Assessment Report

Development Application No. DA0120/22
Date Received 12 April 2022

Proposal Pub and Tourist Visitor Accommodation – Demolition of Existing Structures,

Property Address No.27 Douglas Road KURRAJONG HEIGHTS NSW 2758

Figure A1: 3D Photomontages.

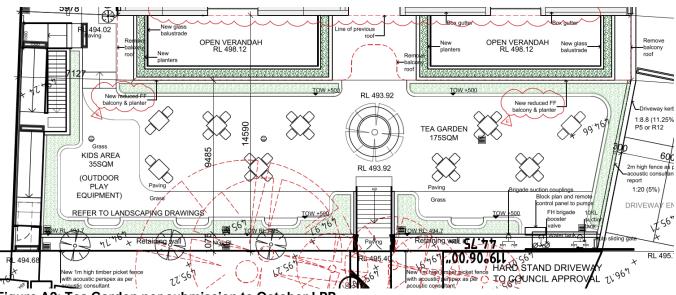
The proposed tea garden has been reduced by bringing the planter boxes and seating closer to the Pub by a distance of 1.6m. This provides two retaining walls to a height of 500mm and 280mm. Refer to Figures A1, A2 & A3.

Figure 11. Streetscape Design and integration along Bells line of Road.

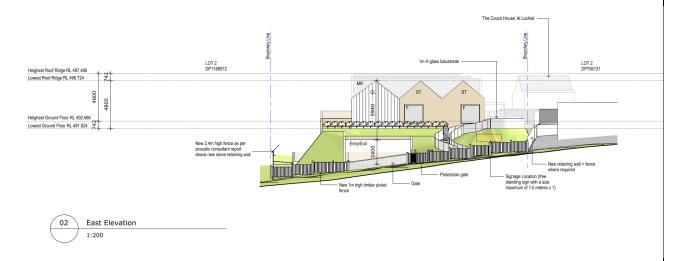
As viewed in Figure 11, it is accepted that 'Lochiel House' is a single storey heritage listed item that adjoins the development site. However as viewed from Bells Line of Road, there is a 20.21m setback between the two developments. Furthermore, the development is recessed behind the front boundary by a distance of 14.5m. It is noted that the development is compliant with Clause 4.3 of the HLEP 2012's 10m height limit.
